**NSLPP MEETING HELD ON 03/08/2022****Attachments:**

ADDRESS/WARD: 54 Benelong Road, Cremorne (S)**APPLICATION No:** DA 292/21/2**PROPOSAL:** Modification of DA 292/21 to include changes to colours and materials of the rear balconies.**PLANS REF:**

OWNER: Owners of Strata Plan 43135**APPLICANT:** Body Corporate Strata Plan 43135**AUTHOR:** Andrew Beveridge, Assessment Officer**DATE OF REPORT:** 26 July 2022**DATE LODGED:** 14 June 2022**RECOMMENDATION:** Approval

Figure 2. Eastern (side) elevation.

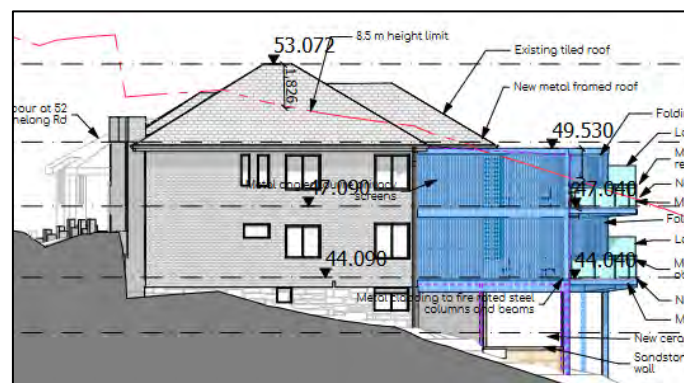
1. Remove operable louvres from the new roof above the approved rear balconies and replace with fixed skylights.
2. Remove bi-folding screen doors from the rear balconies.
3. Remove the common area paved terrace from the basement level.
4. Change the glazed balustrade to a painted steel palisade balustrade.

Figure 10. Section Plan showing the existing and proposed areas above 8.5m in red.

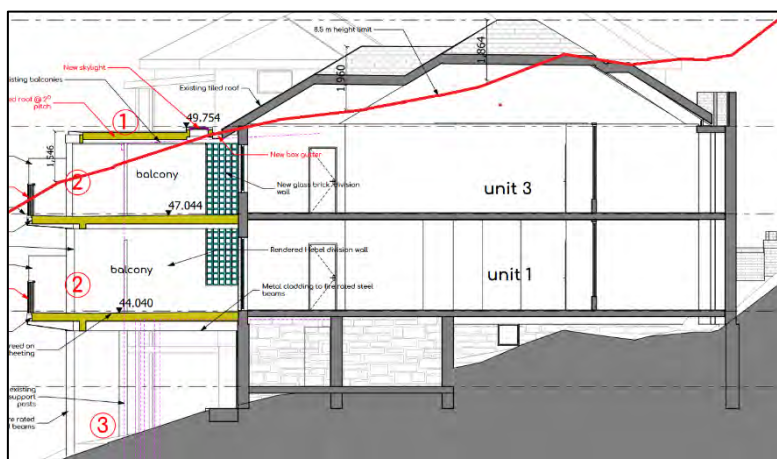
While there is an additional increase in height to that previously approved, the variation of the Development Standard in clause 4.3 as submitted and approved under DA 292/21 continues to apply and does not require a further request for a variation. Nevertheless, an analysis of the additional height is provided in order to establish whether the additional height is acceptable having regard to the objectives of the development standard.

The proposed works would exceed the maximum permitted height. The proposed modification to the previously approved rear balconies results in a variation of 1640mm (19.3%) from the development standard, which is greater than the previously approved variation of 9.93m or 16.6%, as shown in the above table.

Figure 11. The proposed eastern side elevation, showing the 8.5m height limit in red, and the height of the existing rear deck in yellow.

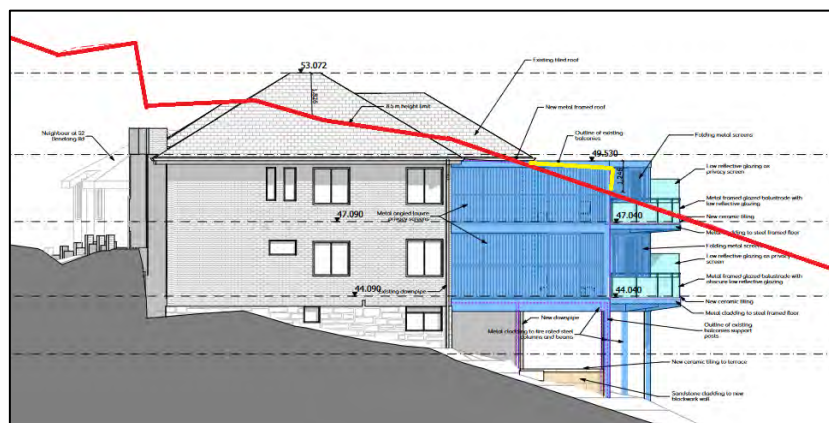
The building has an existing roof ridge height of 10.46m (23%) that fails to comply with the permissible height limit of 8.5m in accordance with clause 4.3 in NSLEP 2013, however this will be unchanged by this proposal. Due to the steep natural fall of the site, the existing rear deck and balconies at the northern end of the building also have an existing non-compliant height of 9.47m (11.4%). The proposed new deck and balcony structure to replace the existing structure will result in a maximum height of 9.94m, representing a variance of 1.44m (16.9%), and consequently requires a variation of the Development Standard in clause 4.3 in NSLEP 2013 (see discussion below).

**PROPOSED FIRST
FLOOR PLAN**

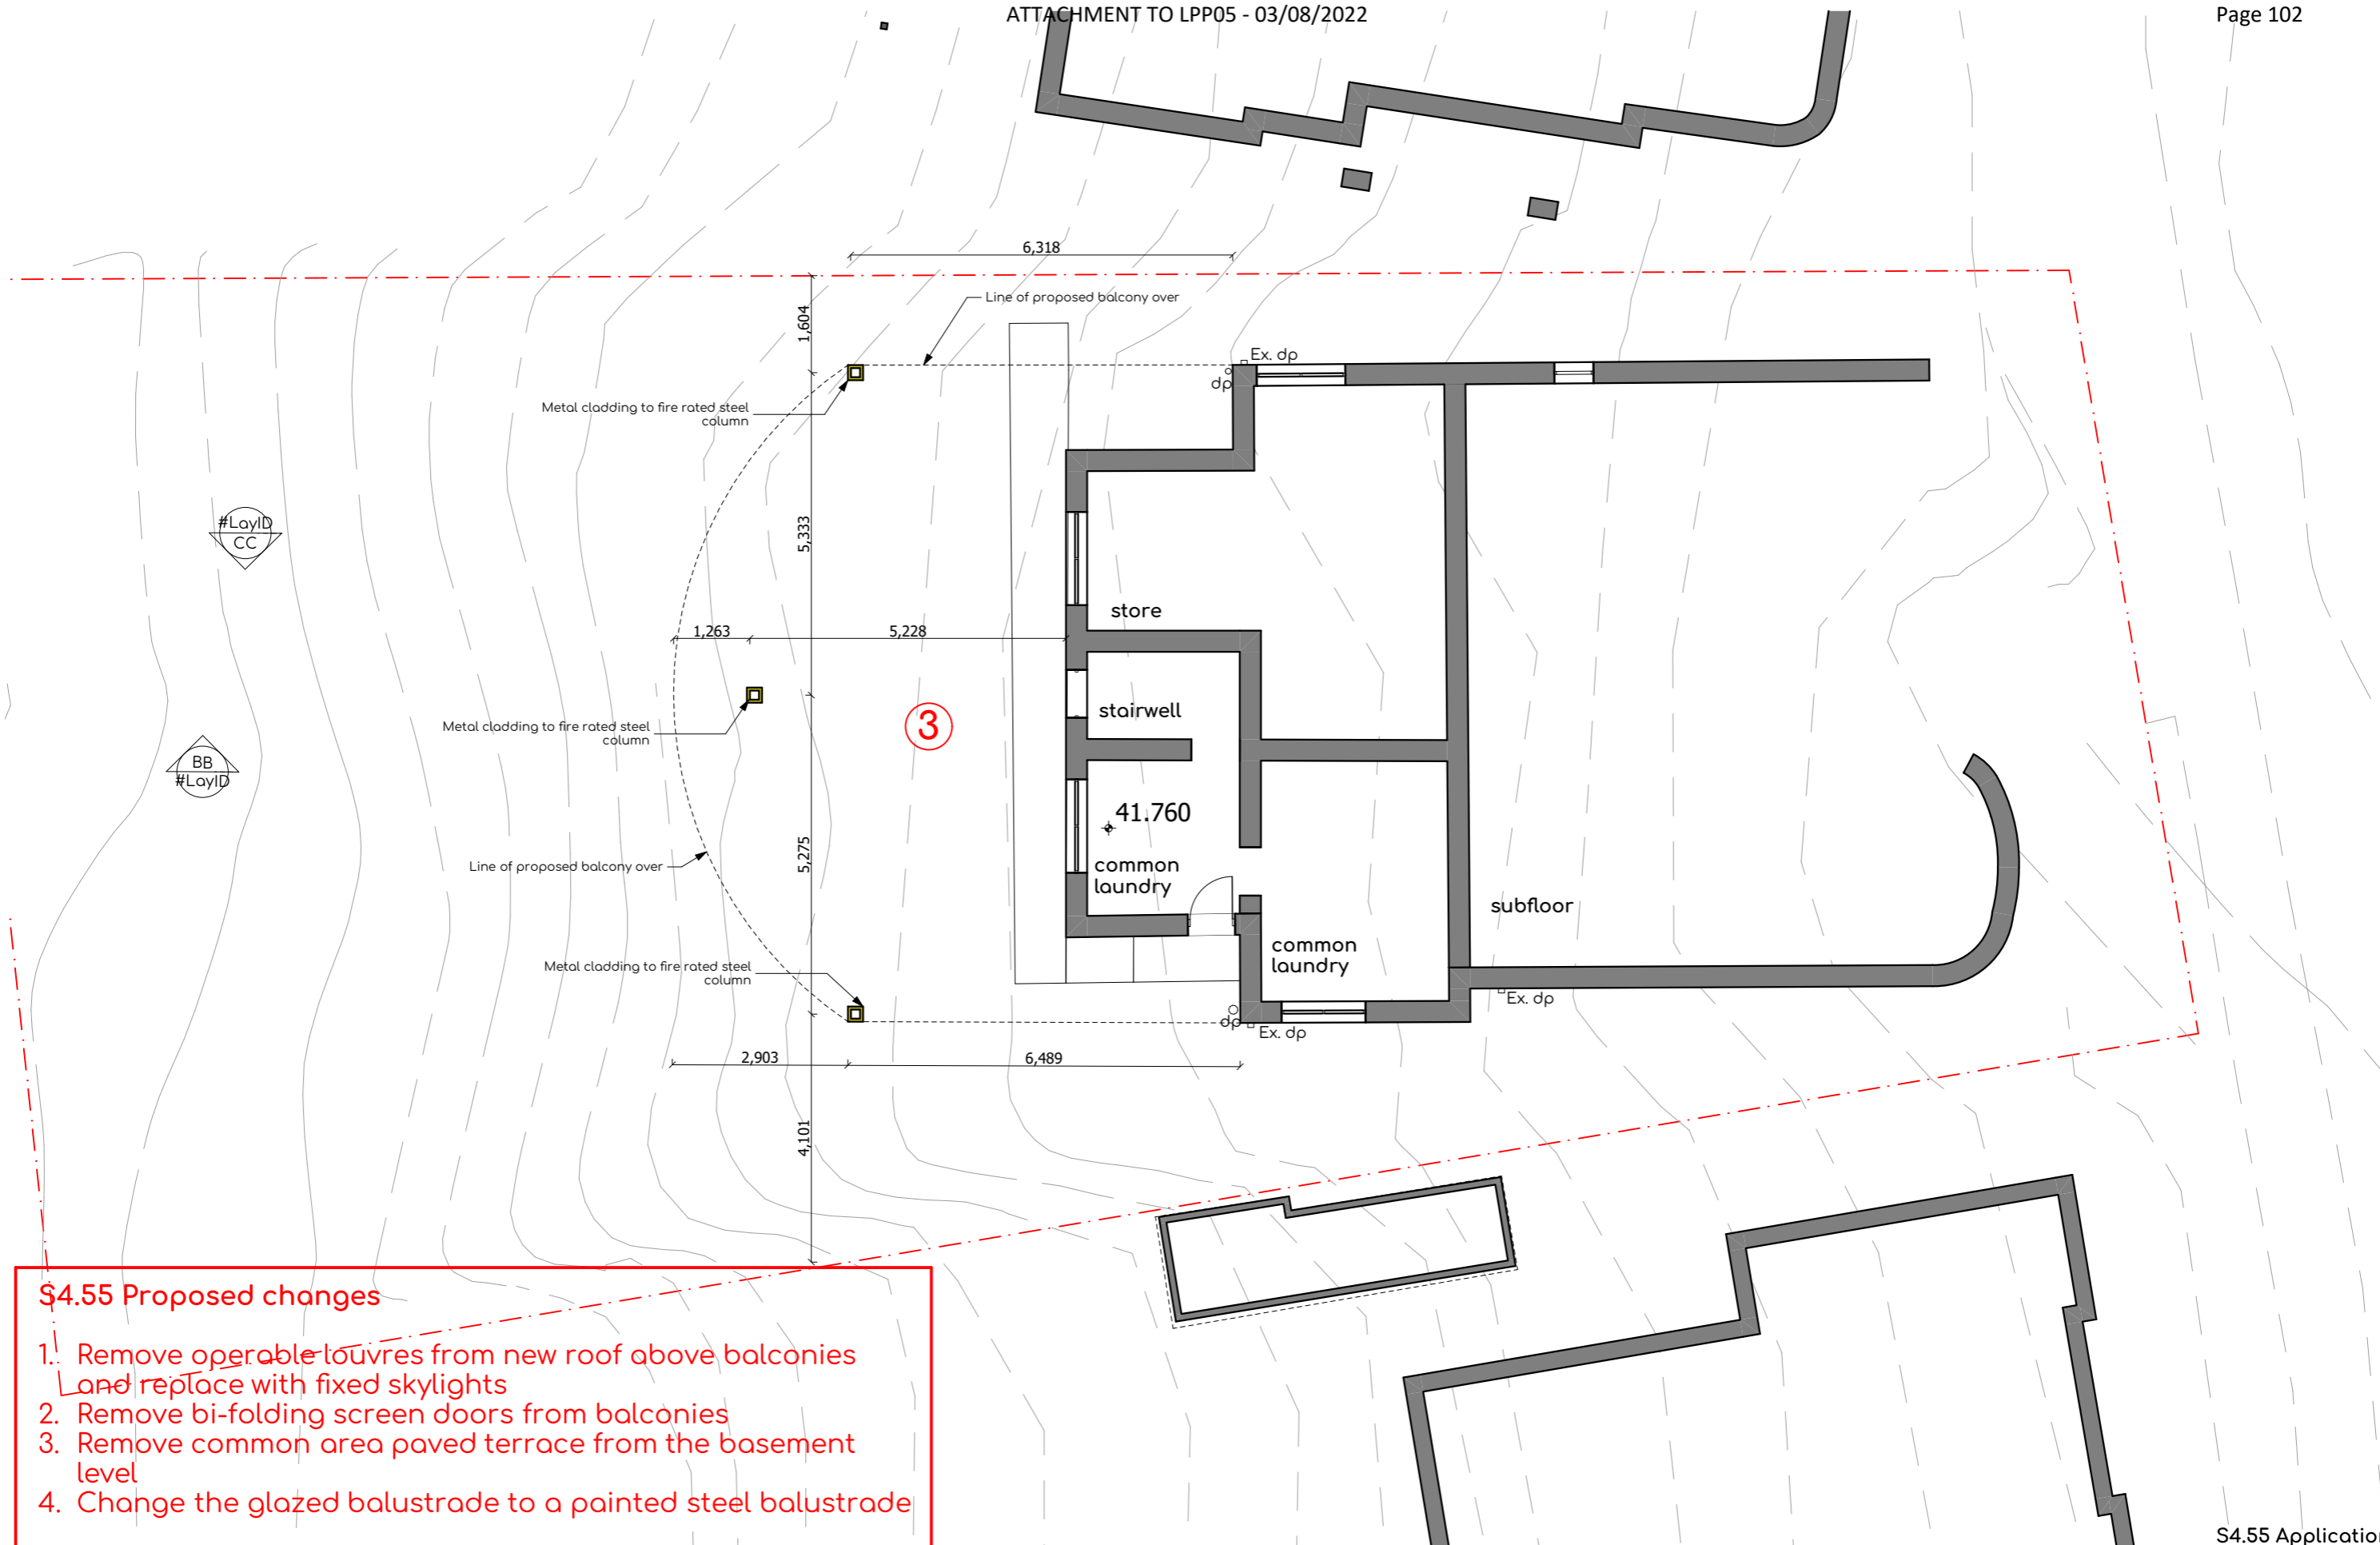
- S4.55 Proposed changes**
1. Remove operable louvres from new roof above balconies and replace with fixed skylights
 2. Remove bi-folding screen doors from balconies
 3. Remove common area paved terrace from the basement level
 4. Change the glazed balustrade to a painted steel balustrade

N & S ELEVATION - PROPOSED

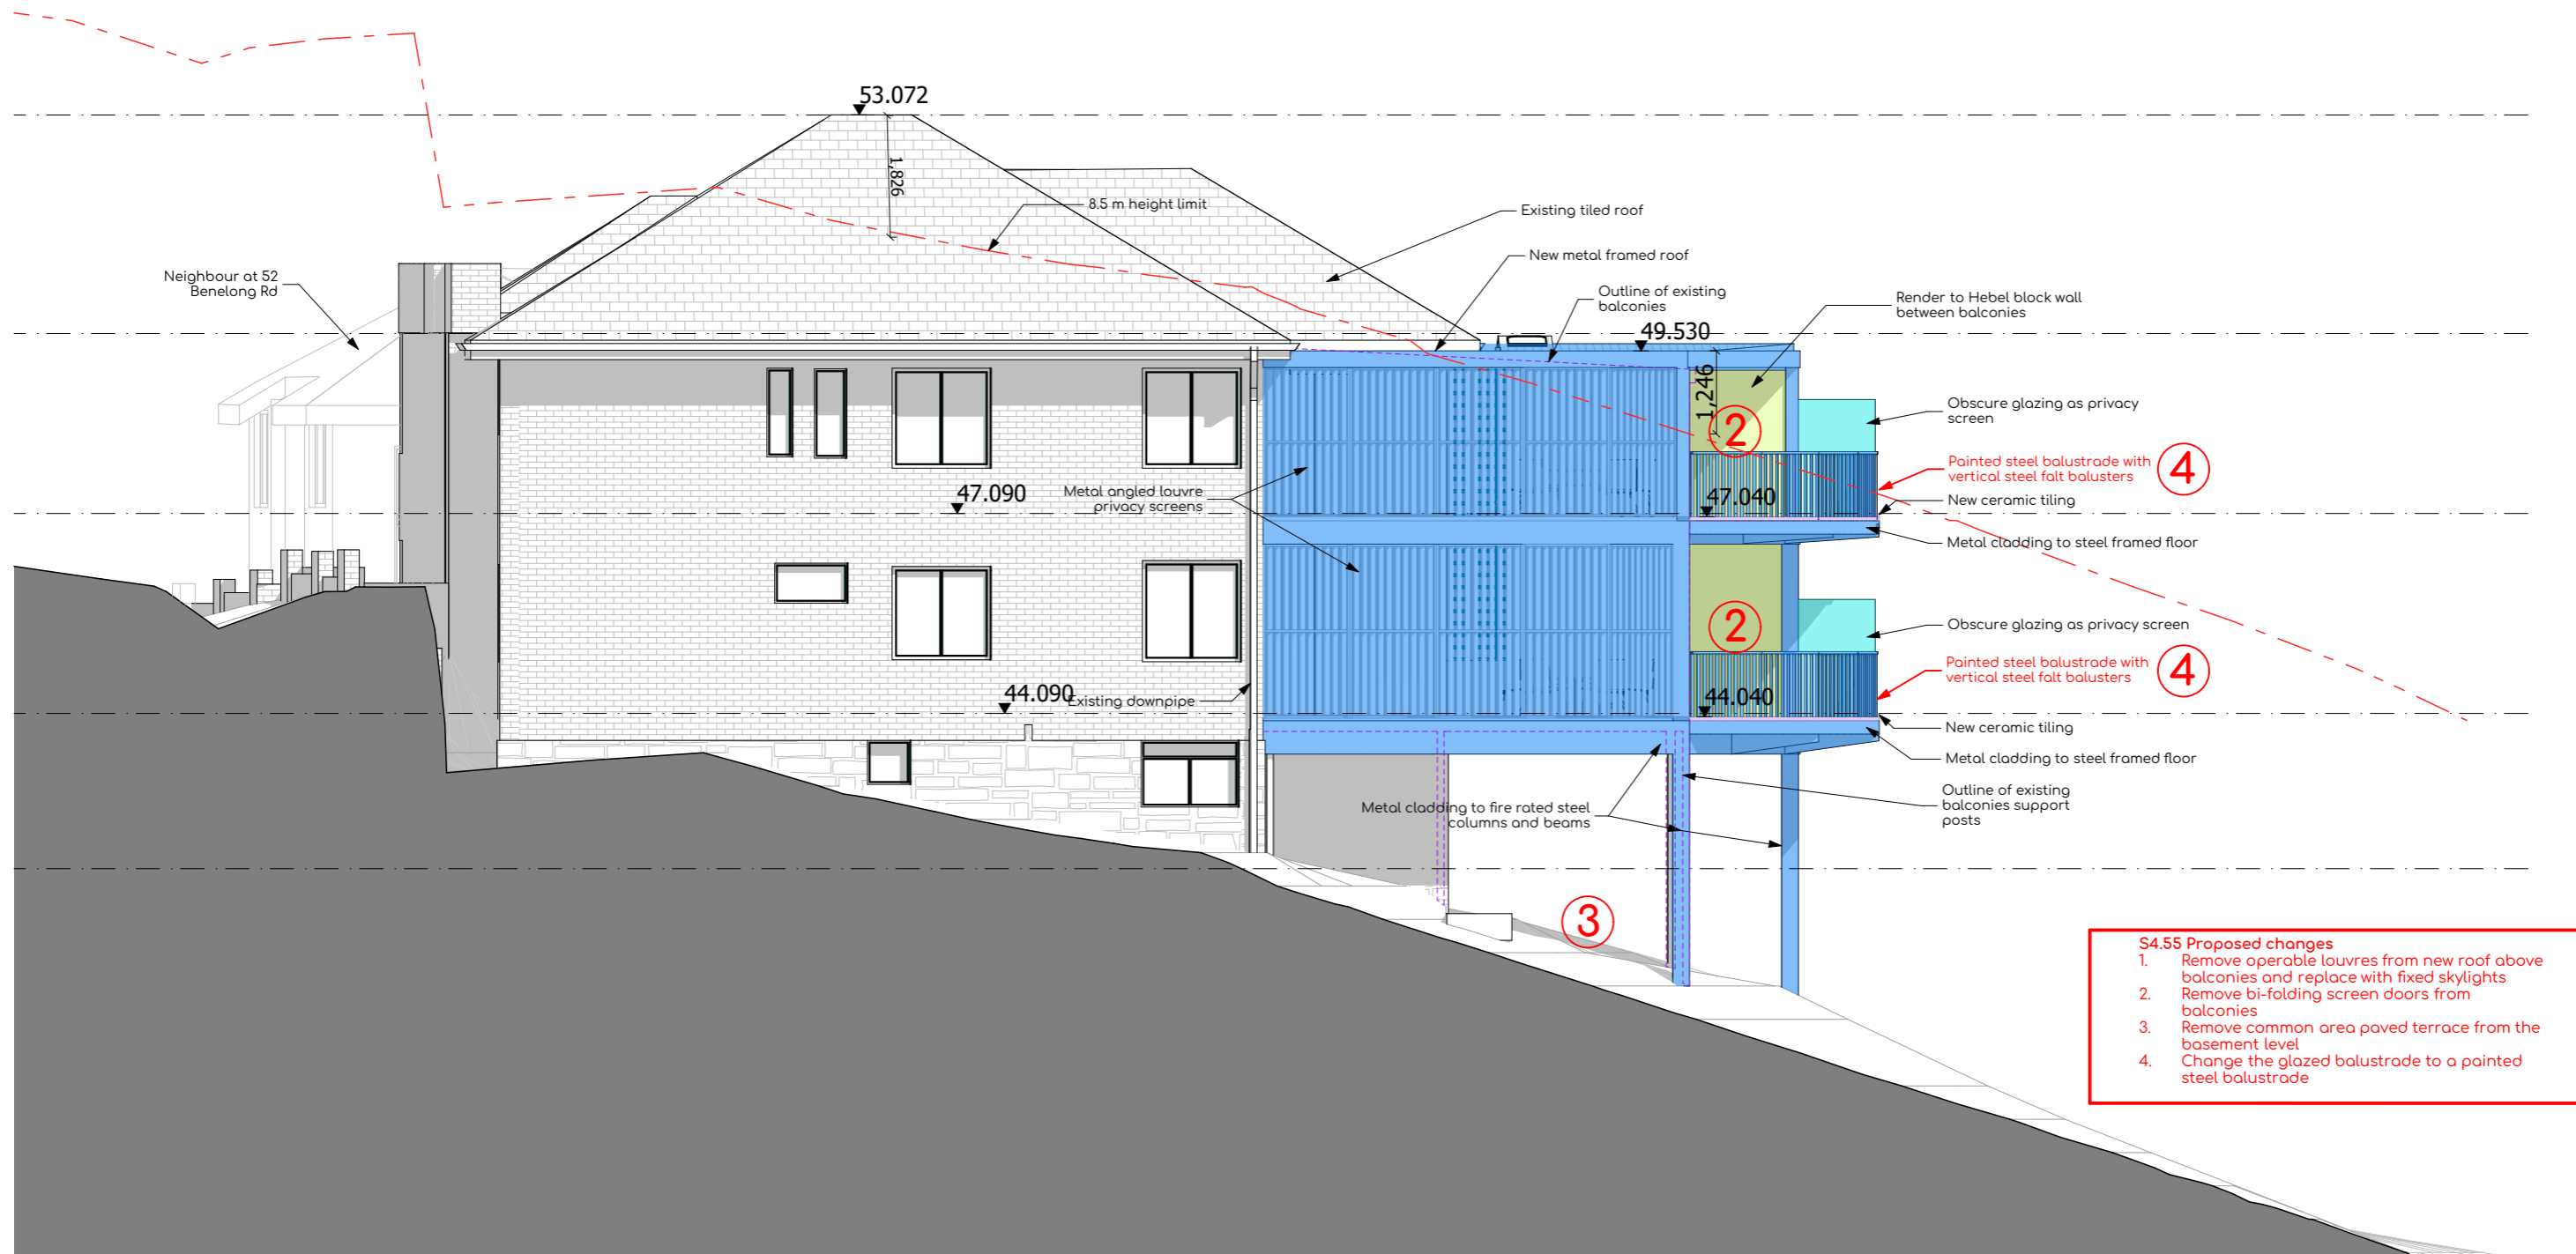
- S4.55 Proposed changes**
1. Remove operable louvres from new roof above balconies and replace with fixed skylights
 2. Remove bi-folding screen doors from balconies
 3. Remove common area paved terrace from the basement level
 4. Change the glazed balustrade to a painted steel balustrade
